# SERVICE BULLETIN

\* Supersedes Service Bulletin SB900-046, dated 20 December 1996.

## HORIZONTAL STABILIZER DRAIN HOLES

Figure 1. Location of Horizontal Stabilizer Drain Holes

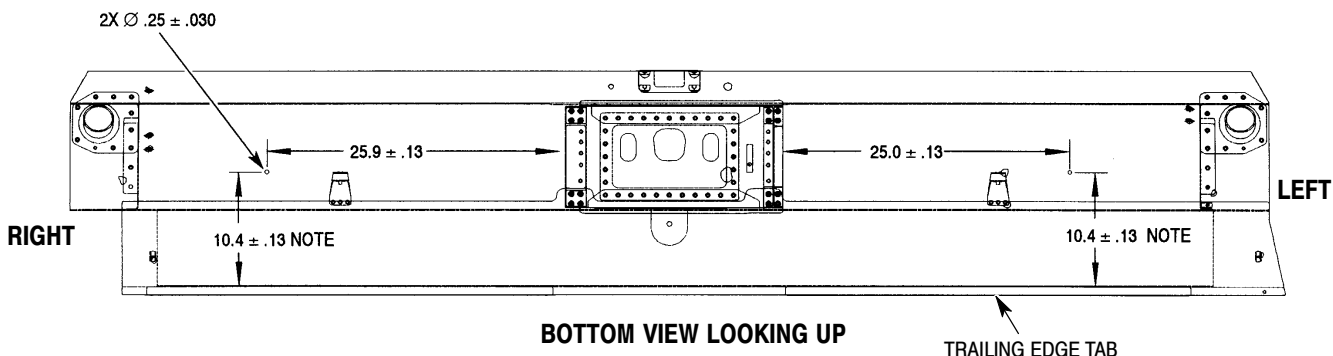
- C. Reason: To provide drain holes to the underside of the horizontal stabilizer immediately underneath the VSCS actuators. This will allow rain and wash water to drain out of the inside of the horizontal stabilizer. Failure to perform the requirements of this Bulletin may result in the VSCS actuators malfunctioning. This condition could result in degradation of directional handling qualities.

- D. Description: Procedures in this Bulletin provide owners and operators with information pertaining to drilling two drain holes on the underside of the horizontal stabilizer.

- A. Remove left hand and right hand VSCS actuators per instructions contained in the Rotorcraft Maintenance Manual (CSP-900RMM-2, Section 67-20-00).
- B. Mark the two locations where holes are to be drilled. (Ref. Figure 1)
- C. Backup the two locations using wood or equivalent. Using a 0.25 inch dagger bit, drill holes at those locations noted in Figure 1.
- D. Touch up holes using paint.
- E. Reinstall left hand and right hand VSCS actuators per instructions contained in the Rotorcraft Maintenance Manual (CSP-900RMM-2, Section 67-20-00).

NOTE: MEASURED ALONG CONTOUR FROM FWD EDGE OF TRAILING EDGE TAB.
